# UNITED STATES PATENT AND TRADEMARK OFFICE

| APPLICATION NO. | FILING DATE | FIRST NAMED INVENTOR | ATTORNEY DOCKET NO. | CONFIRMATION NO. |
|-----------------|-------------|----------------------|---------------------|------------------|
| 10/592,969      | 06/25/2008  | Silvia Gerstner      | 2004P00358WOUS      | 4067             |

| <b>Office Action Summary</b> | <b>Application No.</b><br>10/592,969 | <b>Applicant(s)</b><br>GERSTNER ET AL. |  |

Leimkuehler Fig. 4

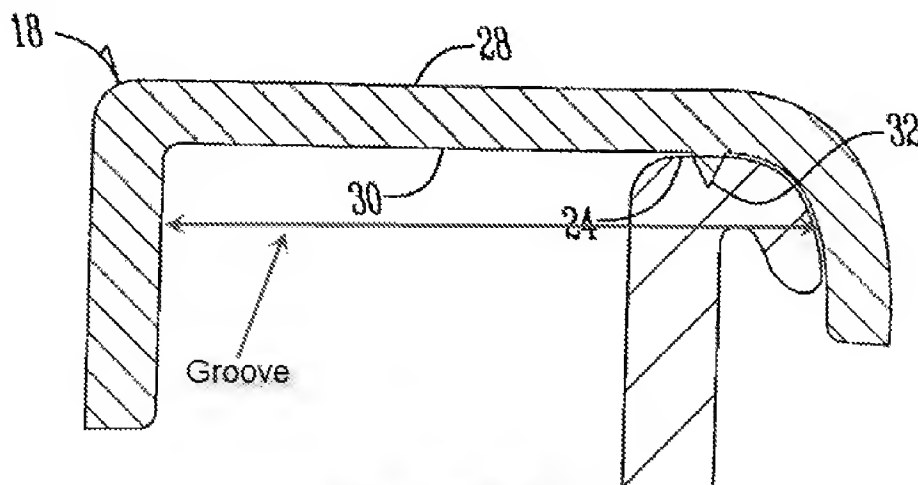
13. Regarding claim 11, Leimkuehler, as modified, teaches a refrigerator wherein the strip has a groove (see annotated Fig. 4) into which the edge of the compartment for accommodating articles to be cooled is inserted (Fig. 4).

14. Regarding claim 12, Leimkuehler, as modified, teaches a refrigerator wherein the depth direction of the groove is aligned transversely to the radius of curvature of the decorative strip (Fig. 4).

15. Regarding claim 13, Leimkuehler, as modified, teaches a refrigerator wherein the width of the groove increases, at least at certain points, from an inlet region of the groove to its bottom (Fig. 4 shows the width of the groove to increase from the top (inlet region) to its bottom).
